TOPIC Snug Harbor – Multiple Family Site Plan Review

Subject: VLO-24-01 Snug Harbor (160 Heights Road), Site Plan Review #1

Re: Snug Harbor
Site Plan Review #1
NFE Job No. 0039

Date:	02.29.2024
Scale:	1"=10'
Sheet:	C3
Project:	20107.40

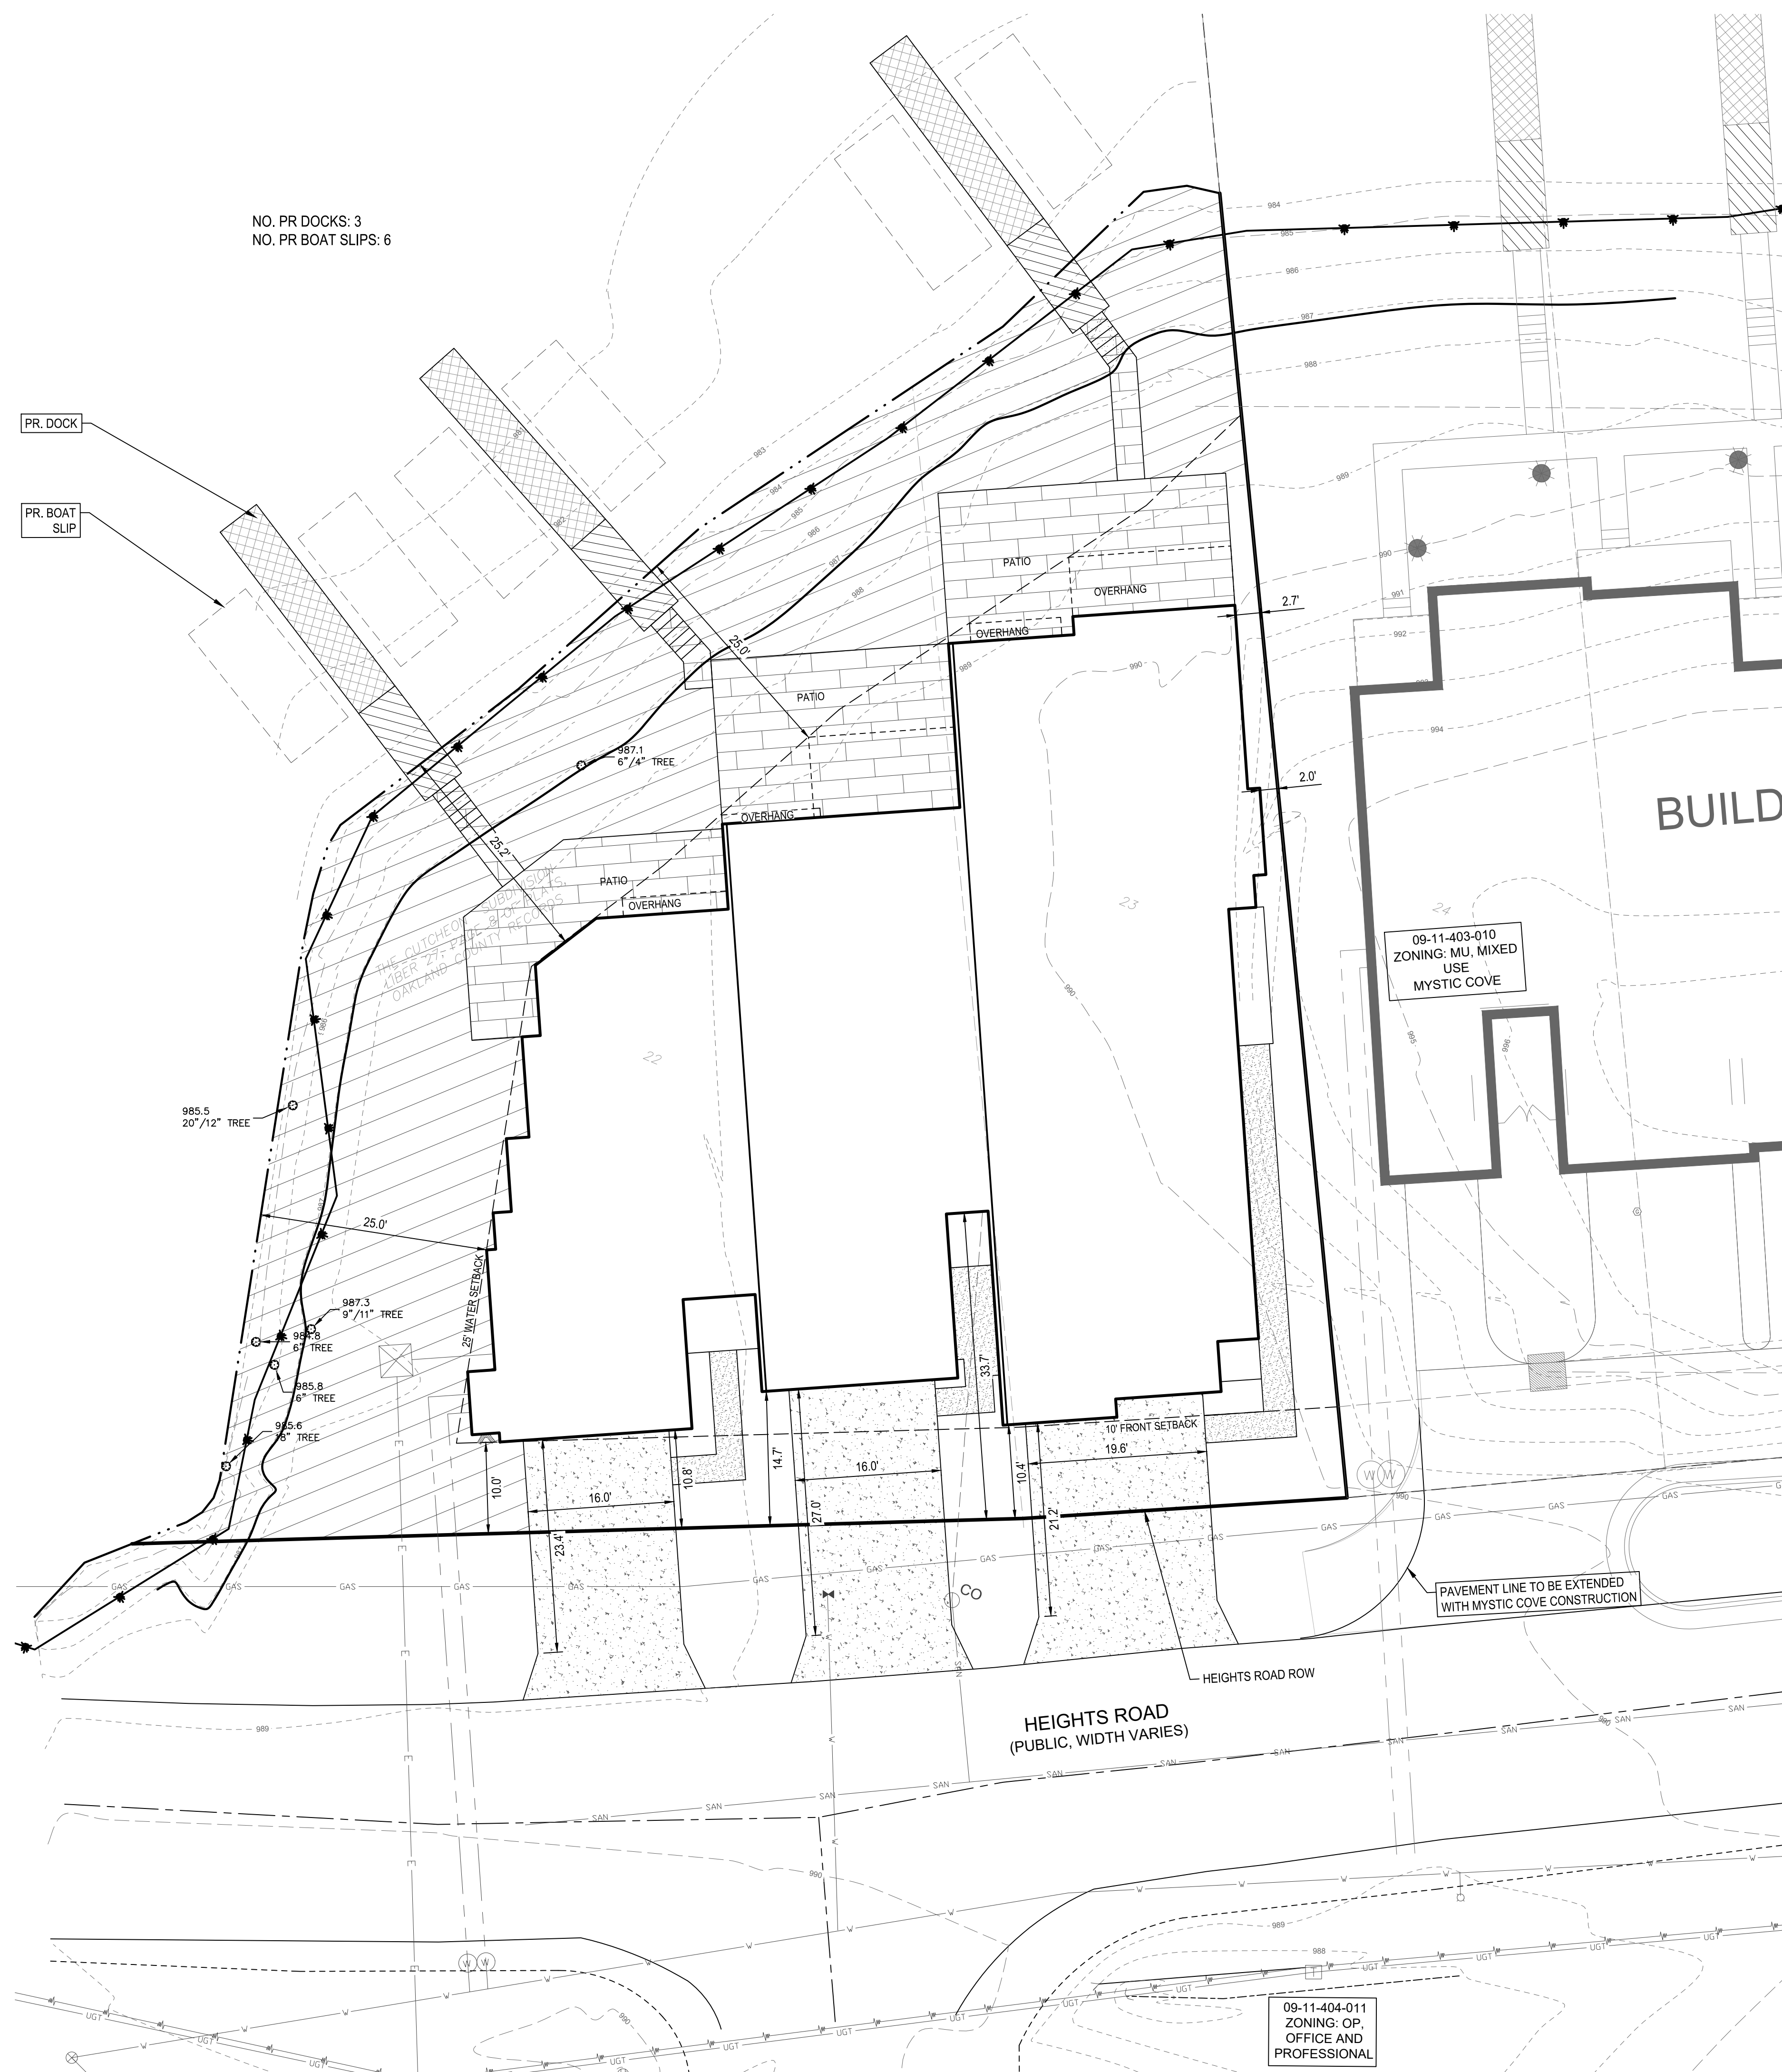
Vehicular Access. Vehicular access to the site is provided from three driveways which extend from Heights Road to the garages, which face Heights Road. The existing curb cut on Heights Road will be eliminated as part of this project. Development standards in the MU District encourage cross access between sites; given the size and characteristics of the site and surrounding neighborhood, we do not find this would serve public health, safety, or access. The site plan is subject to the standards of the Township Fire Marshal regarding emergency access and fire suppression.

Findings: Per Section 14.02, two parking spaces are required per dwelling unit. Both townhomes include a 2-car garage and both stacked flats include a 1-car garage. While there is driveway space extending from the garages to the road, these are majorly within the right of way and do not provide the necessary off-street parking required for the flats. The required off-street parking must be provided or satisfactory data shall be furnished to support a reduction in off-street parking requirements by the Planning Commission.

Date:	02.29.2024
Scale:	1"=10'
Sheet:	L1
Project:	20107.40

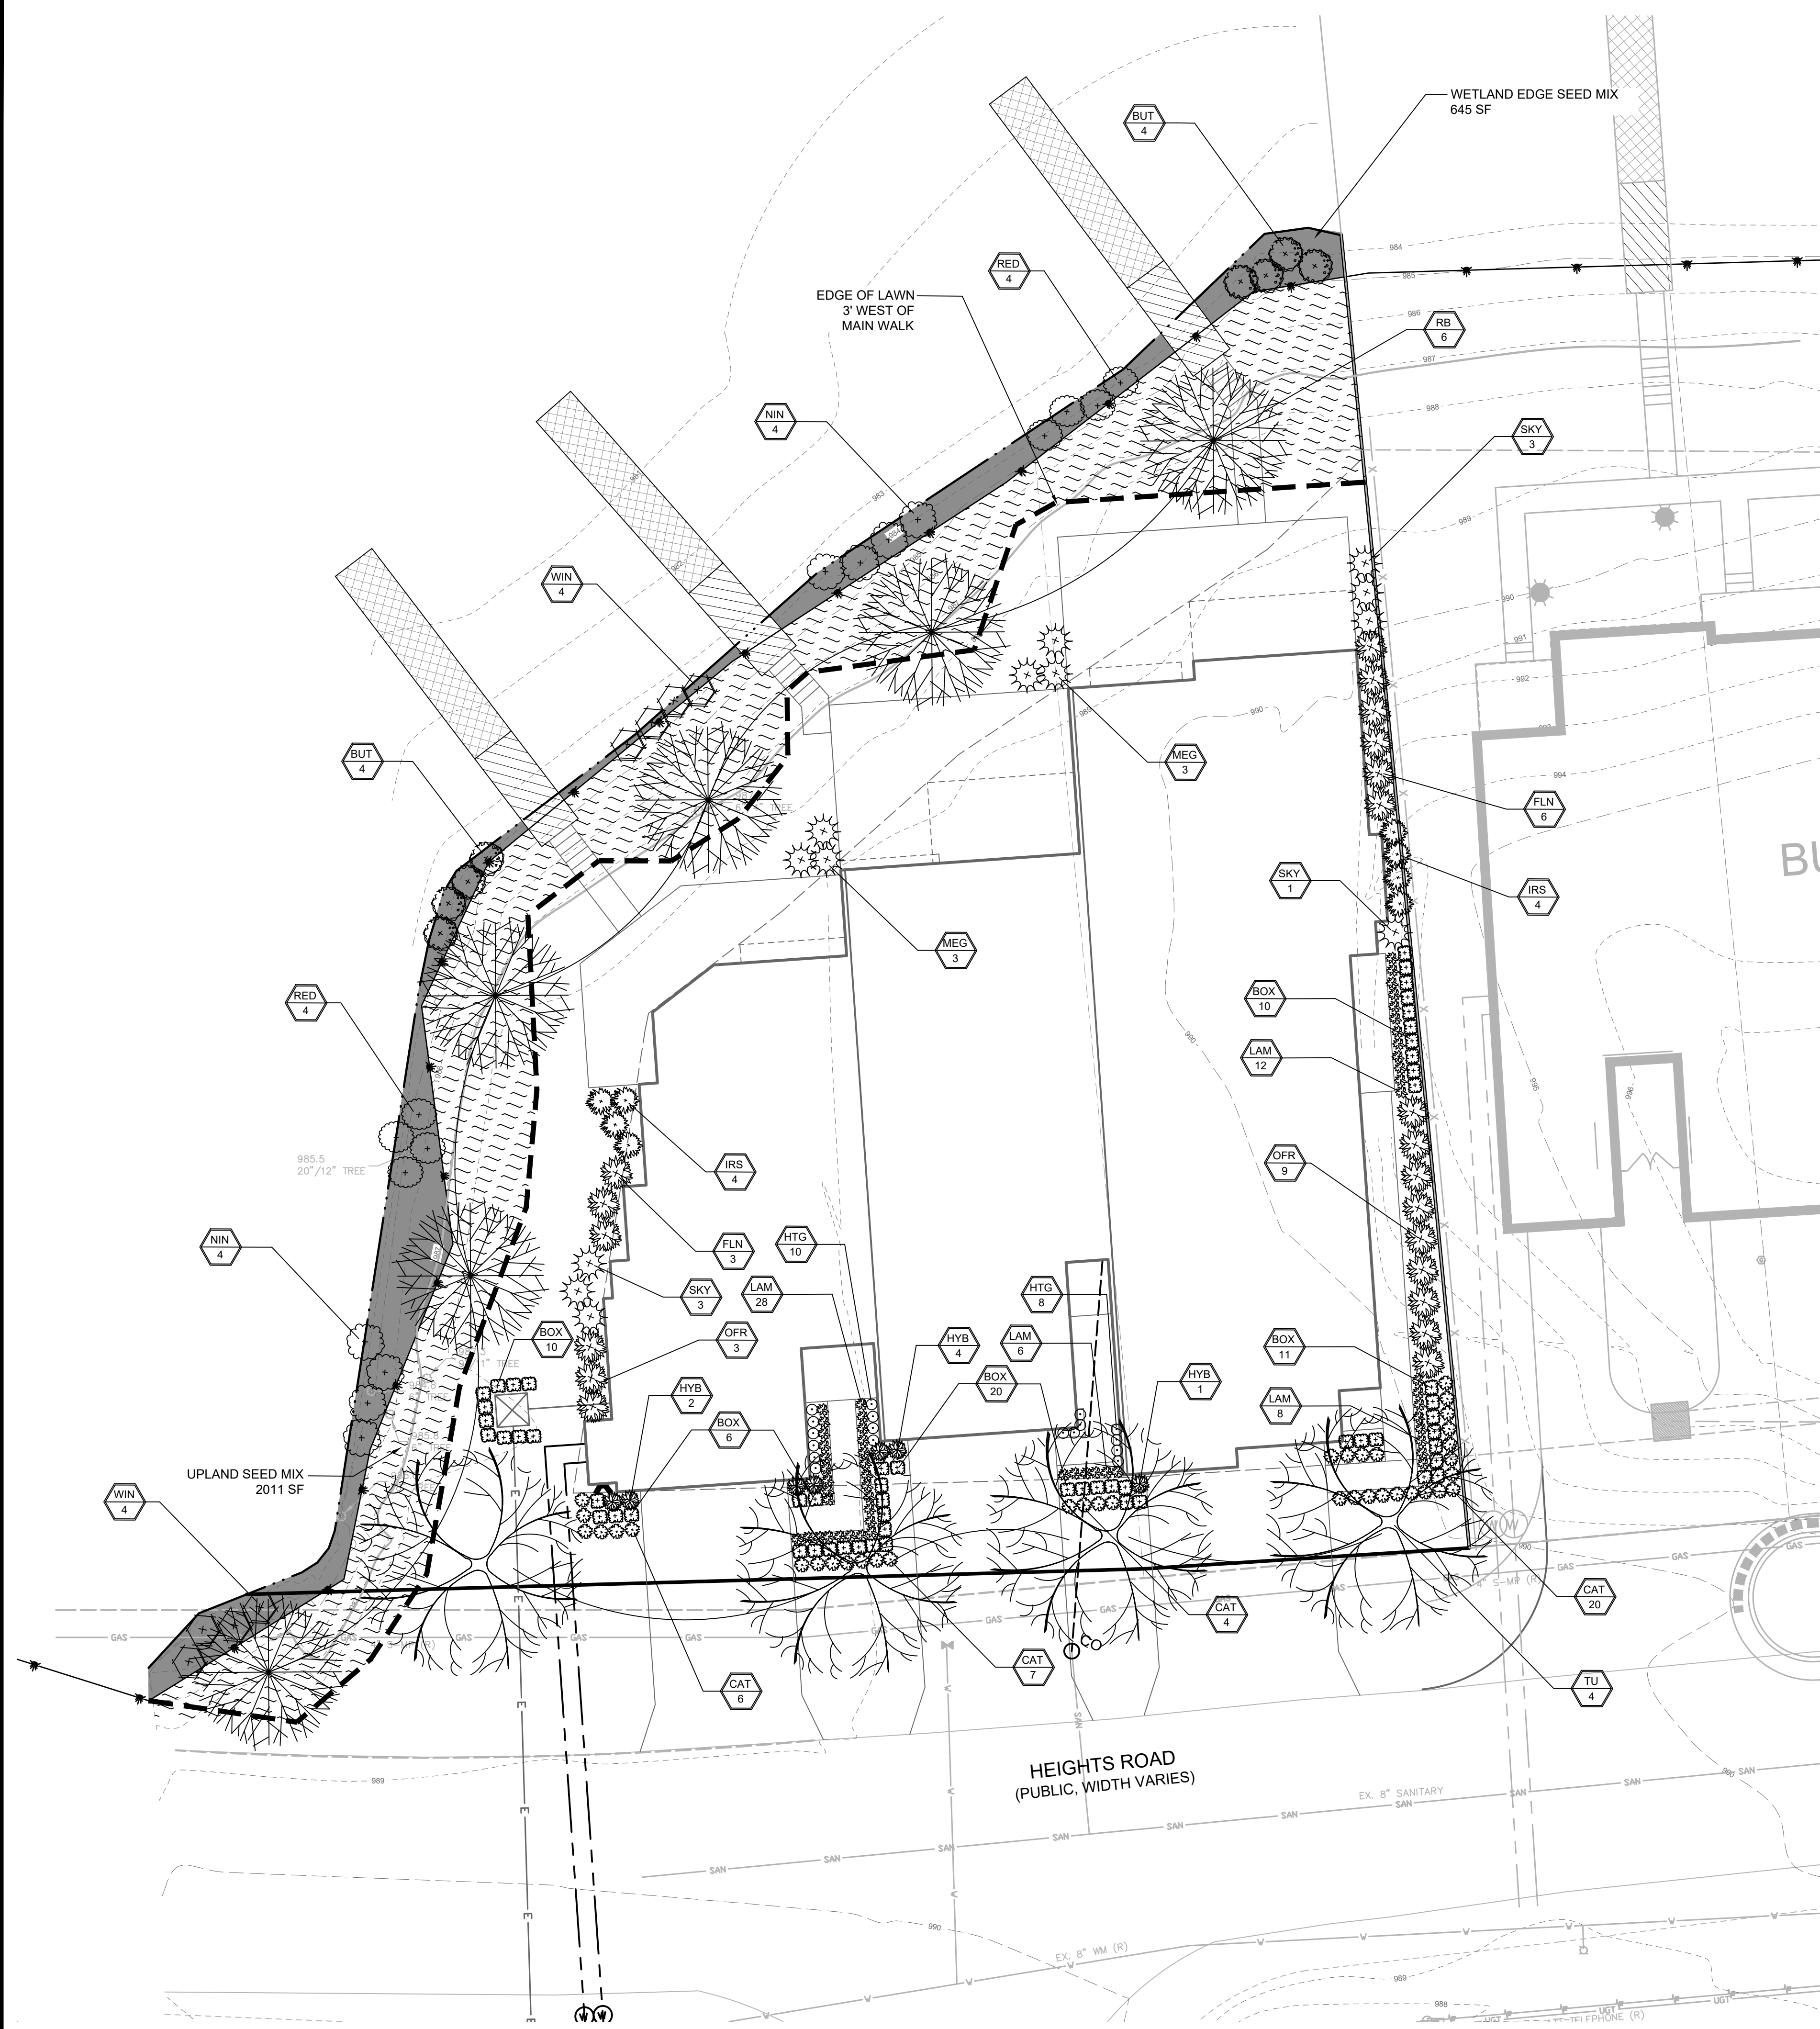
Landscaping and Plant Material. The applicant has provided a landscaping plan on sheets L1 and L2. The following landscaping and screening standards are relevant to this Project:

Plant Materials and Landscape Elements. The proposed plant materials and landscape elements must be of high quality, be of diverse species types, and follow the required plant material specifications. While the proposed plant material is of high quality, they do not fulfill diversity requirements. There are also

minor discrepancies in plant material specifications (11 river birch are noted, but only 6 are shown on plan; 9 fine line shrubs are noted, but 30+ are shown).

The Ordinance requires that no single plant species comprise more than 20% of any category of plant material. The landscaping plan does not comply with this diversity requirement; however, we recommend that the Planning Commission waive this requirement, consistent with other multifamily developments in the MU district, to promote a cohesive design within a smaller site.
